**RESPONSE TO REQUEST FOR ADDITIONAL INFORMATION ON THE  
DRAFT SECTION 3116 DETERMINATION FOR SALT WASTE  
DISPOSAL  
AT THE SAVANNAH RIVER SITE**

June 30, 2005

Westinghouse Savannah River Company  
Closure Business Unit  
Planning Integration & Technology Department  
Aiken, SC 29808

Figure 18-1.3-D stream traces from Vault 1 with 5-year timing markers for the GSA\_PORFLOW Model

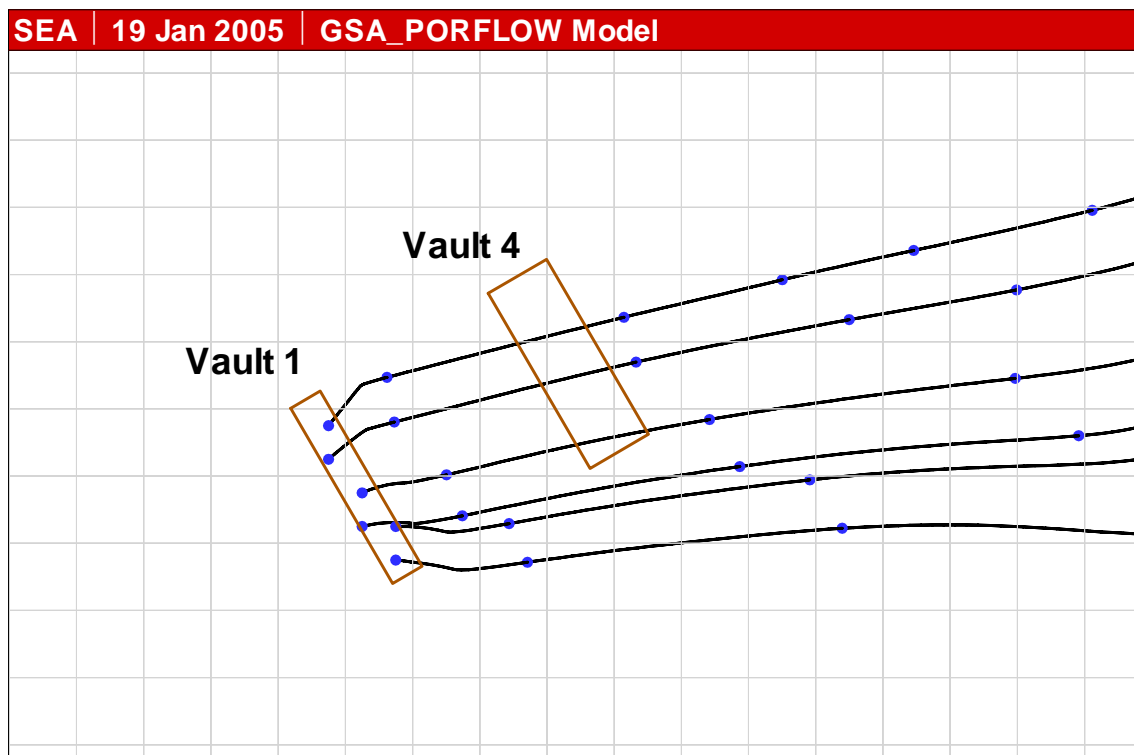
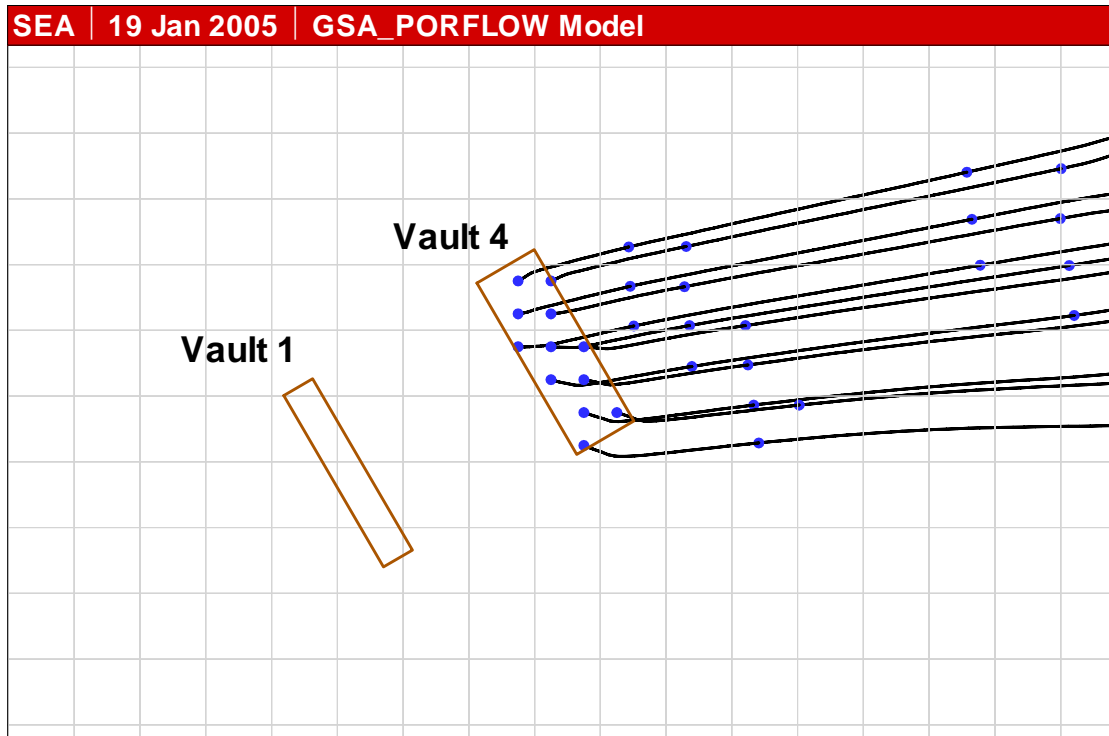
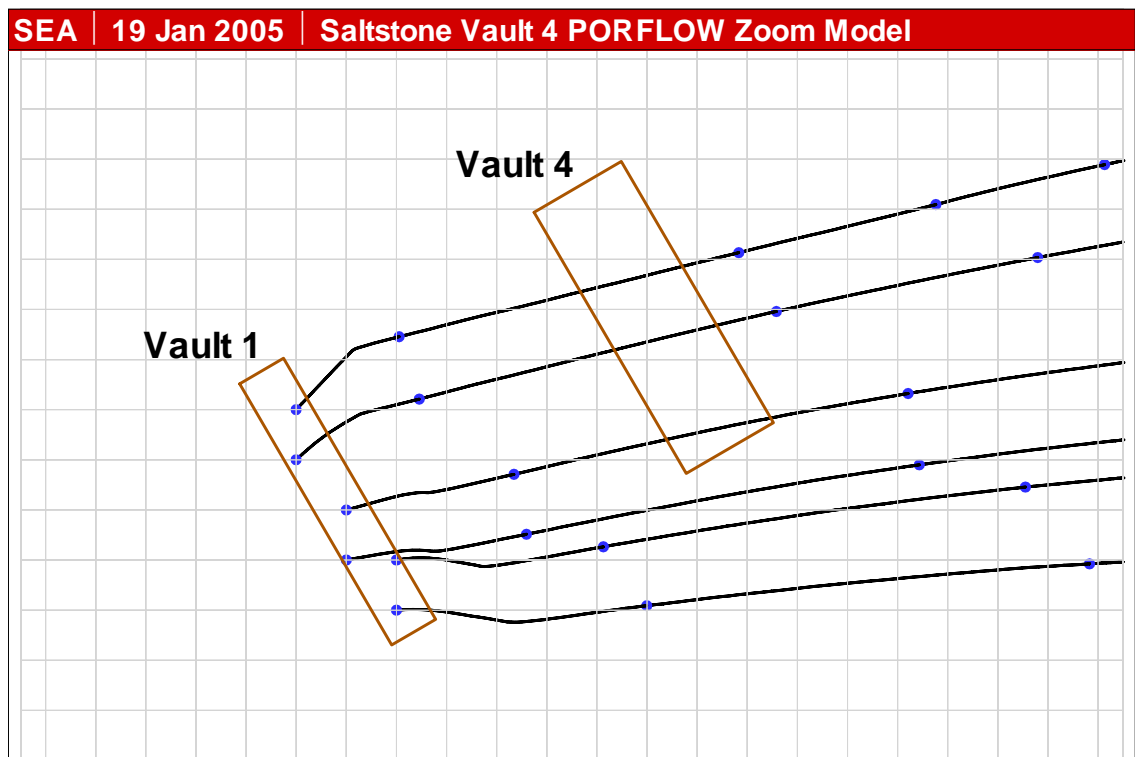
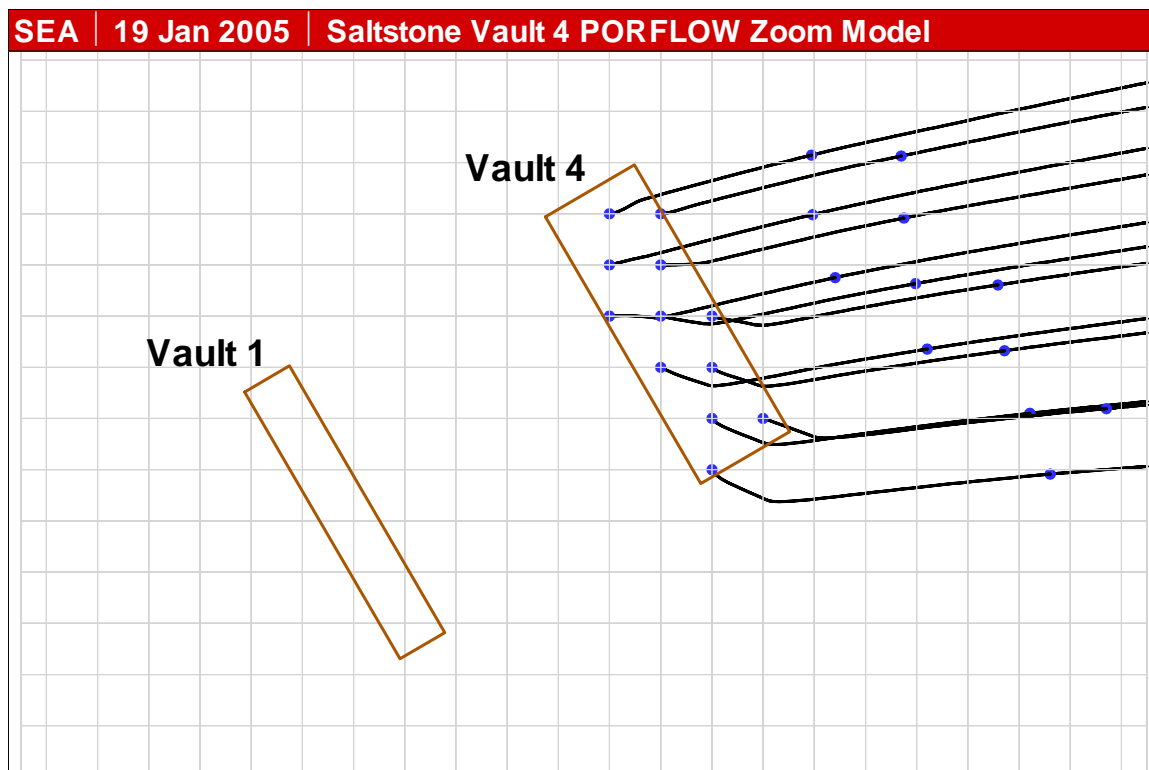
Stream traces from Vault 1 (Figure 18-1 or 18-3) indicate an advective travel time under 10 years to reach Vault 4. What is the impact of upstream potential sources from Vault 1 on plume interaction with Vault 4?

Figure 18-5. 100 foot and 100 meter well locations relative to Vault 4

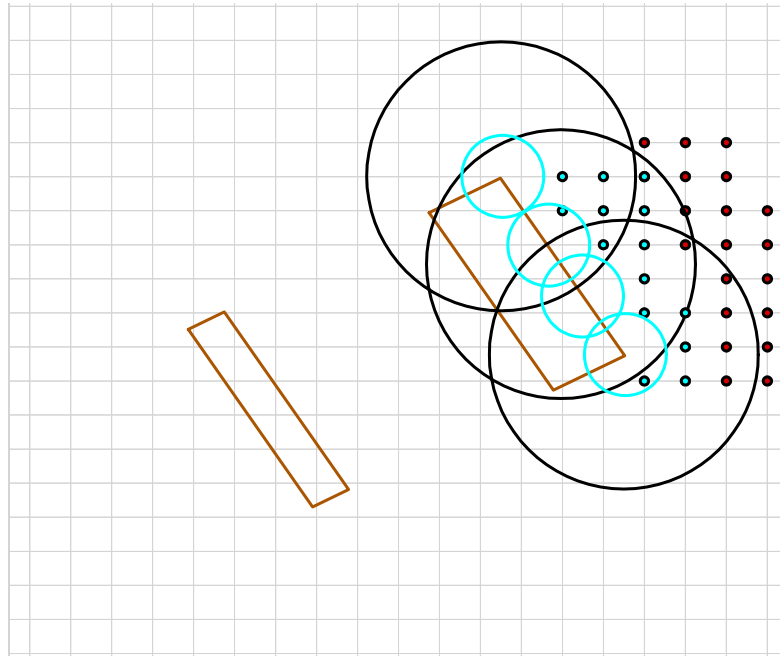
The nodes representing the maximum concentration outside a 100 foot or 100 meter buffer zone are shown in Figure 18-5. I cannot determine at this time if these nodes are adequate to capture the maximum concentration until a small subset of aquifer runs with revised internal sources are executed and results from the STAT command are reviewed.
